# CITY OF ALBUQUERQUE

**Re: Paseo del Norte Sportsplex Drainage Report**  
**Engineer's Stamp dated 12-29-04**

Based upon the information provided in your submittal dated 12-29-04, the above referenced report is approved for Site Development Plan. Prior to Building Permit approval, please address the following comments.

## **Paseo Del Norte Sportsplex Albuquerque, New Mexico**

## Overflow Channel

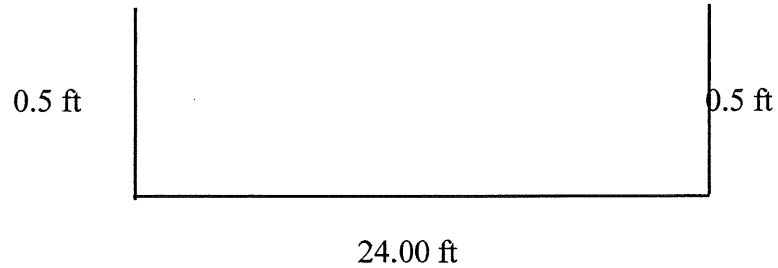
- Please direct the emergency spillway toward Paseo del Norte.
- How does the runoff leave the pond? Does it daylight to the existing grade?
- Please check the volumes of the pond – they appear small. This will probably affect the AHYMO run.
- Pipes 7 and 8 are undersized. Also, please check your weir calculation.
- Please include exhibit from the previous report (C17-D19) showing allowable discharge to the property to the west.

### EMERGENCY SPILLWAY DETAILS

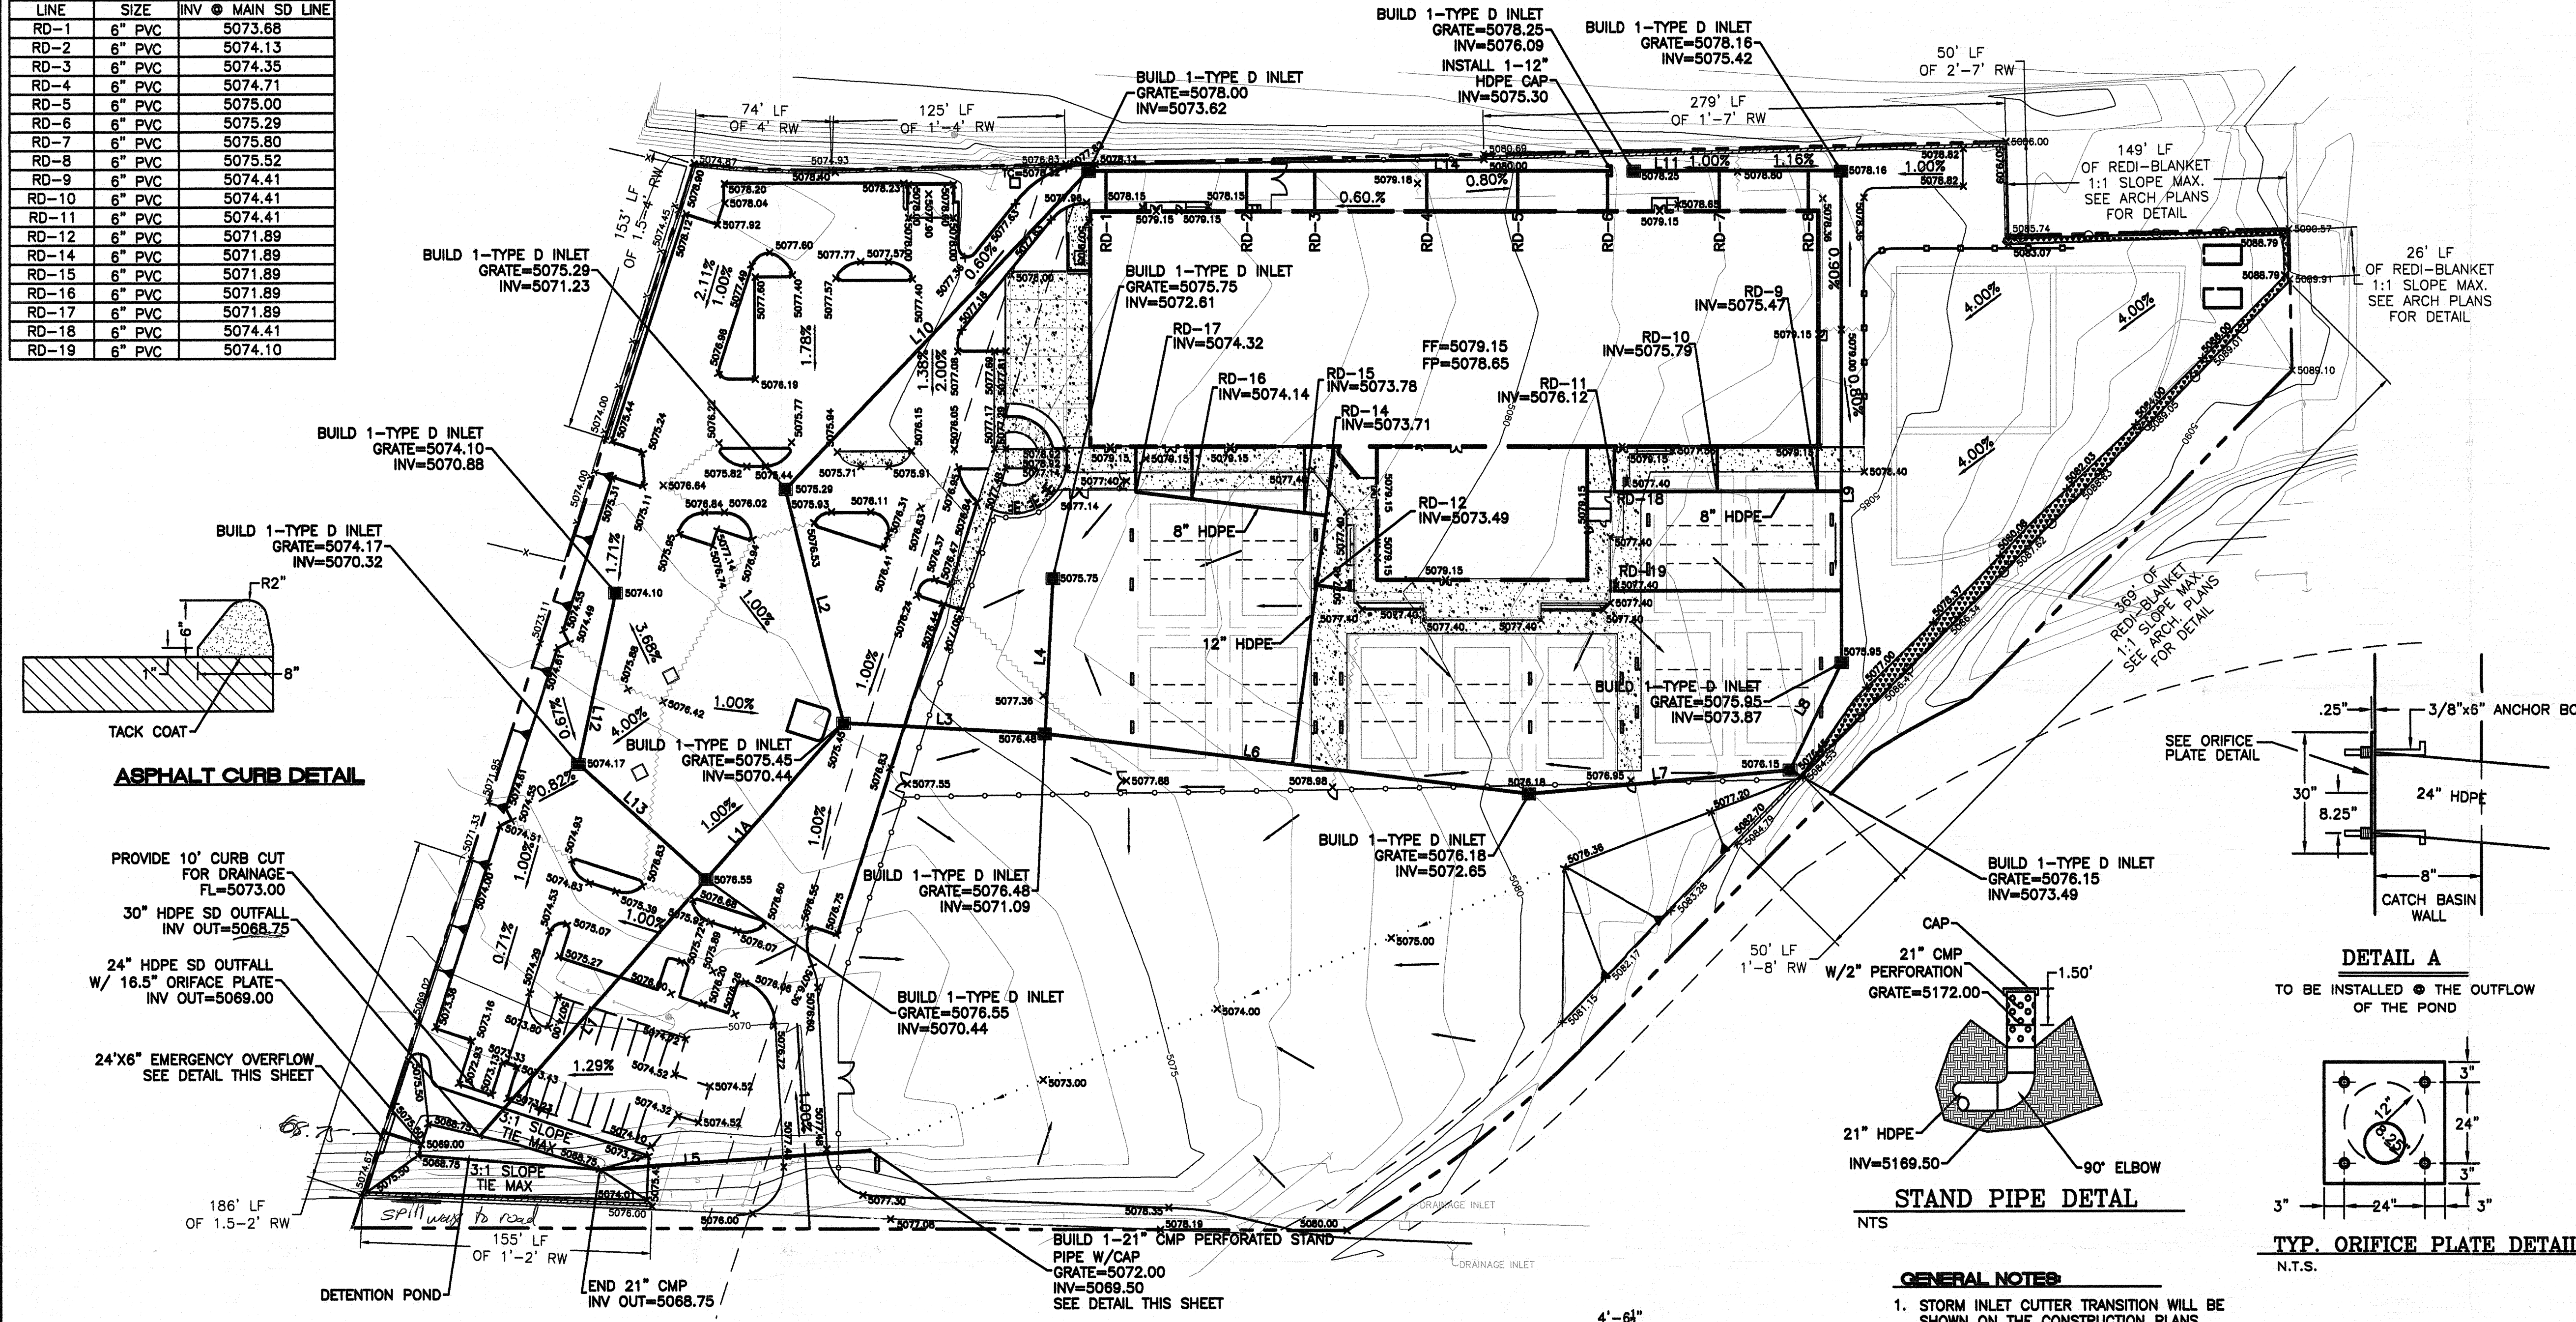
3. provide excpts from (C-17-119) denote allowable runoff  
1. point spill to road  
2. water get out of pond?
